Re: Request for a one year extension of the approval of the Preliminary Plat of Harmony Hills 2nd Addition.

PRELIMINARY PLAT
HARMONY HILLS ESTATES SECOND ADDITION
BEING A PART OF THE SOUTHEAST QUARTER AND PART OF THE NORTHEAST QUARTER OF SEC. 28 TOWNSHIP 78 NORTH, RANGES 2 EAST OF THE 5TH PRINCIPAL MERIDIAN, SCOTT COUNTY, IOWA
DO NOT RECORD

PLANNING & ZONING COMMISSION
STAFF REPORT
August 19 2008

**GRANTING A ONE YEAR EXTENSION OF THE APPROVAL OF THE
PRELIMINARY PLAT OF HARMONY HILLS 2ND ADDITION.**

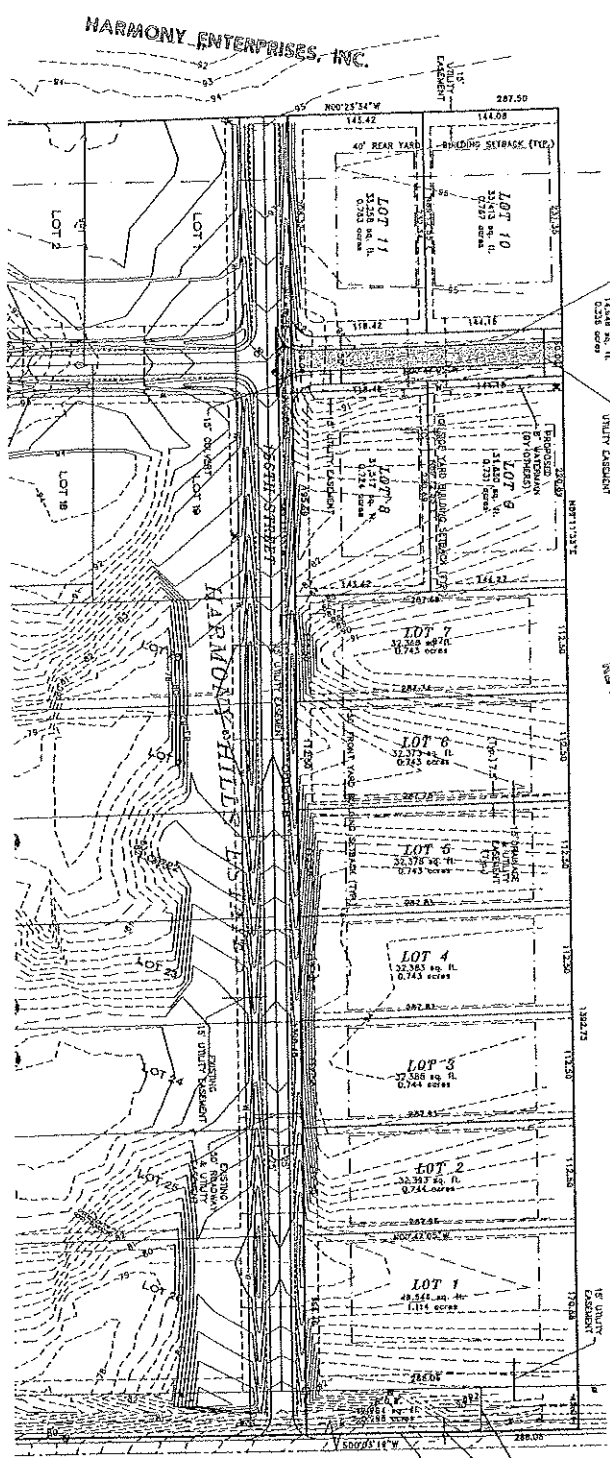
STAFF REVIEW: Staff has reviewed this Preliminary Plat for compliance with the Subdivision Regulations. This plat loads the north half of 156th Street with eleven (11) additional lots. It also shows a street being extend at the west end of 156th Street to provide a future connection to the adjacent undeveloped property. Until such time as the approximately 40 acres of land to the north is developed the existing road that was constructed during the first phase of this development would serve as the developments only access to Y-48.

Iowa-American water mains has been extended to serve these lots. Wastewater treatment will be handled by on-site systems with either septic drain fields or sand filters.

The applicant's engineer has not, as of yet, submitted an erosion and sediment control plan. The County Engineer will review those plans when submitted. The Natural Resources Conservation Service will also be asked to review those plans. The developer is also required to obtain a State permit from the Iowa DNR for grading an area of this size. Staff has requested a copy of that permit also be submitted

The Health Department has reviewed this plat and stated that they have no major concerns. They did note that soil percolation tests will be required after site grading is completed and prior to Final Plat approval.

RECOMMENDATION: Staff recommends that the Preliminary Plat for Harmony Hills Second Addition be approved with the following conditions:

1. The City of Davenport also review and approve the Preliminary and Final Plat prior to Final Plat approval by the Board of Supervisors;
2. That no Final Plat that would result in greater than fifty (50) total lots for any portion of the Harmony Development be approved until a second access is provided;
3. The stormwater drainage and erosion control plan be reviewed and approved by the Soil Conservationist at the NRCS;
4. The proposed wastewater treatment facilities meet Health Department requirements;
5. The County Engineer review and approve all street construction plans prior to construction; and
6. The subdivision infrastructure improvements be completed or a surety bond posted prior to Final Plat approval.
